Addendum No. 1 To Proposal

P25-02 New Construction of a Fire Hall, Fire #4, in the community of Alliston, ON

January 23, 2025

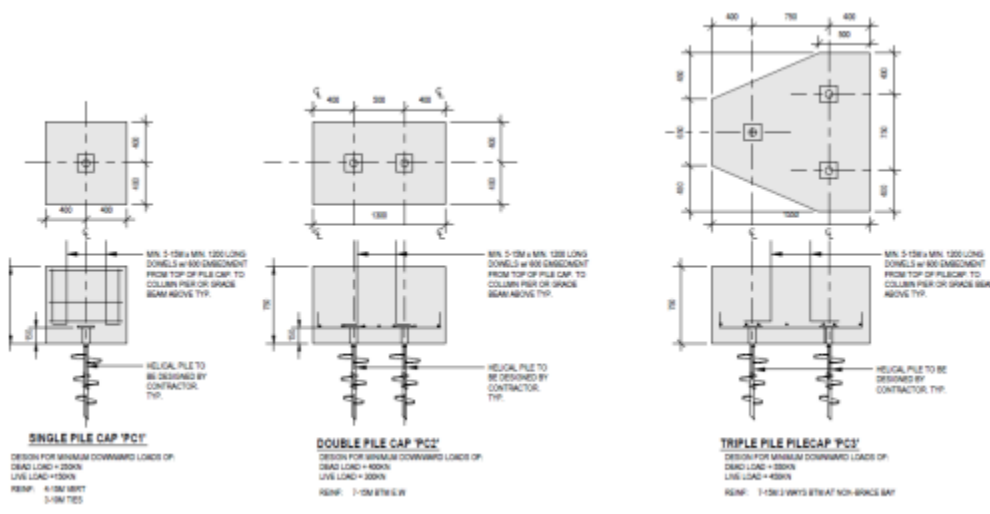
Question No. 30

Drawing S200 specifies to design the piles for ULS loads of 500kN (compression) and 150kN (tension). However, drawing S220 specifies to design the piles based on pile cap dead and live loads. Can you please clarify which loads to design the piles for?

Answer No. 30

Use the indicated loads in notes 17 and 18 (above) as a 'per pile' design load criteria. Use the loads indicated in the images as a 'per pile cap' design load criteria. Note that the pile top plate connections at vertical braces to have uplift design criteria of 450KN per drawings.
